Docket Item #15 A&B

DEV. SPECIAL USE PERMIT #2007-0005(A)
SPECIAL USE PERMIT (TMP) #2007-0051(B)
THE MADISON

Planning Commission Meeting
December 4, 2007

REQUEST: Consideration of a request for approval of a development special use permit with site plan for a residential/retail mixed use building with underground parking; increased floor area; a parking reduction; a transportation management plan; and modifications.

Figure 12. Bulk plane requirements.

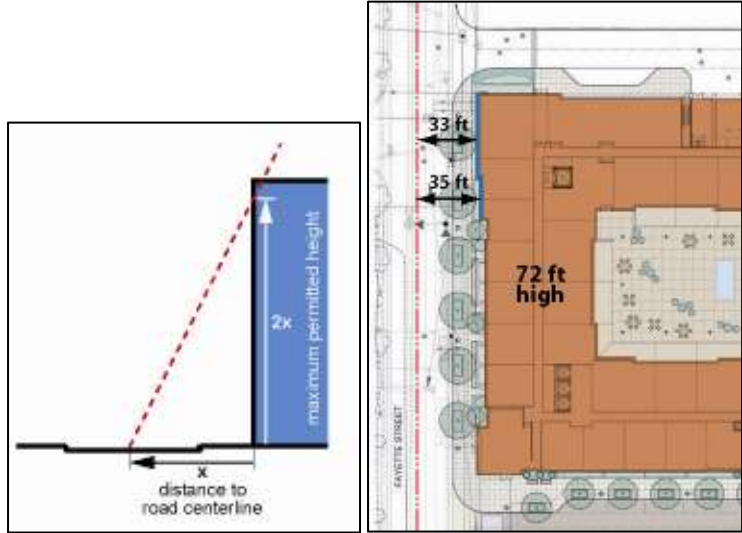
Although the CRMU-H zone does not have yard requirements, the Zoning Ordinance requires that the building be set back from the centerline of the street it faces a distance equal to at least half the height of the building at every point. The intent of this bulk plane/setback provision was to ensure an appropriate distance between buildings on each side of the street. At the northwest corner of the site along Fayette Street, the portion of the building that does not meet the setback requirements is 72 feet tall with a 33- to 35-ft. setback from the centerline. This setback rule requires a minimum 36-ft. setback from the centerline of Fayette Street, and therefore, the portion of the building in this location either needs to be pulled back 1-3 feet or be lowered.
